Doc or ECO #:	ECO-70683-001	Date:	9/11/18	Author:	CH
	Rev. #:	A				
Pro4 Video Capture Device Replacement	Engineering Approval:	Aeg	Date:	9/11/18	Quality Approval	DO

P/N #:	70683	Effective Date:	September 11, 2018
Title:	Ruggedized MSS Power Supply Capacitor Modification

Figure 1. Cap to be removed.

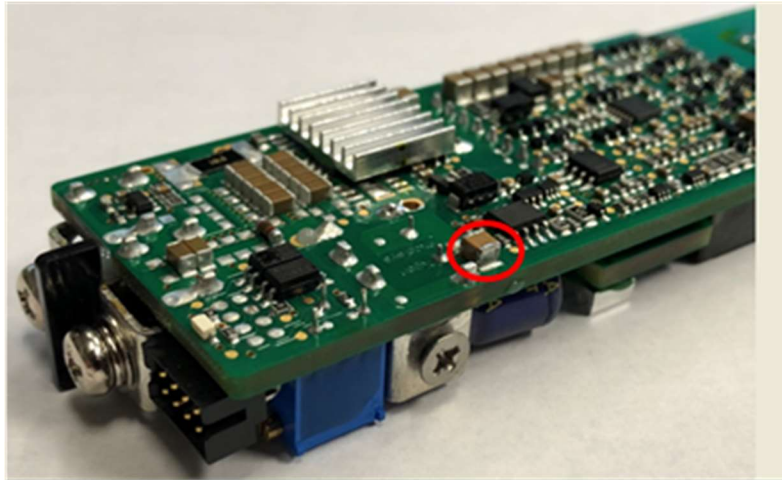
Excelsys evaluated the data and determined that the modules on the power supplies were leaking current on to the chassis and reaching the AC ground lines. This is due to the power modules radiated EMI being coupled to the chassis and dumped on the AC ground line. This was done by design to mitigate radiated EMI for CE certification.

After considering different options, it was determined by Excelsys that the best solution was to remove the cap that bridges the power modules to the chassis and prevent leakage current from reaching the AC ground line. This modification will be done by Arrow prior to shipping. Videoray assemblies will not be affected by this change.

The same cap is removed on ALL modules we use. Both on the MSS ICB and the IP65 ICB.
